GBC DESIGN, INC.

Subject: **Chick-fil-A #1539 Grove City**
GBC Project No. 51151R

The following is in response to your comment letter, dated 10/20/2022, for the above subject.

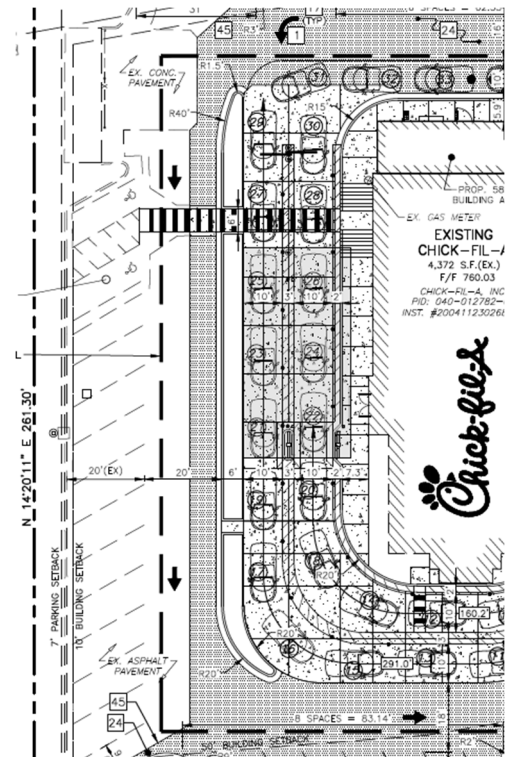
1. Staff is not supportive of the canopy material. Canopies need to match the building material and appear as an extension of the building as has been done for other area drive-thru or canopy structures such as Chase Bank (4100 Buckeye Pkwy) and Sonic Drive-In (1799 Stringtown Rd). The canopy on the west side of the drive-thru should connect to the building.

GBC Response: Canopy column material has been revised to match the existing building and appear as an extension of the building. This canopy is installed as a free-standing canopy to cover the order point locations and protect team members taking orders. This is prototypical design for the Chick-fil-A sites and this one happens to be close to the building based off the order point locations.

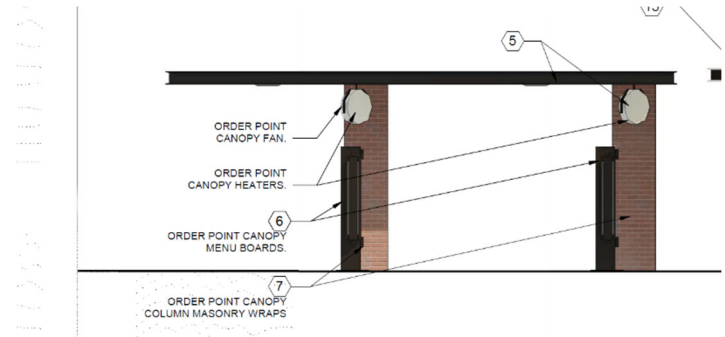
- Plan sheet showing stacking capacity during peak hours is required.

GBC Response: *Stacking capacity has been provided as requested. See Sheet C-200.*

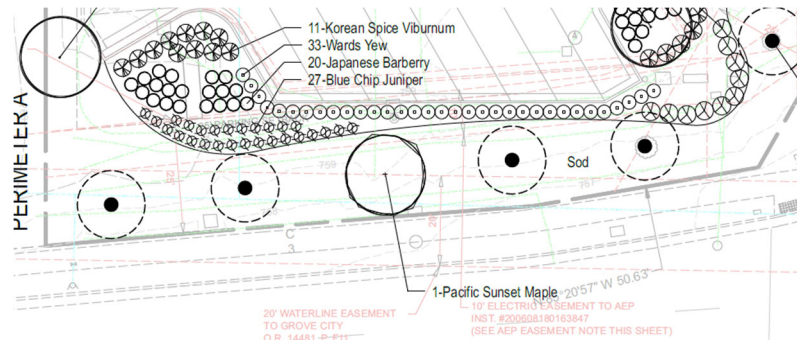
- Staff is not supportive of the removal of the landscape areas along the side (west), rear (north), and front (south) of the building. Per code a tree needs to be planted for every 50 lineal feet of building perimeter, so 7 trees are required to be planted around the building. Any landscaping (trees and shrubs) removed from existing planting areas will need to be replaced.

GBC Response: *Most existing plantings will be disturbed by new curbing. Instead of keeping a few scattered here and there, we thought it would be best to refresh all the landscaping except the ones near the dumpster. Plan revised to show (1) tree per 50 LF of building perimeter on sheet L-100.*
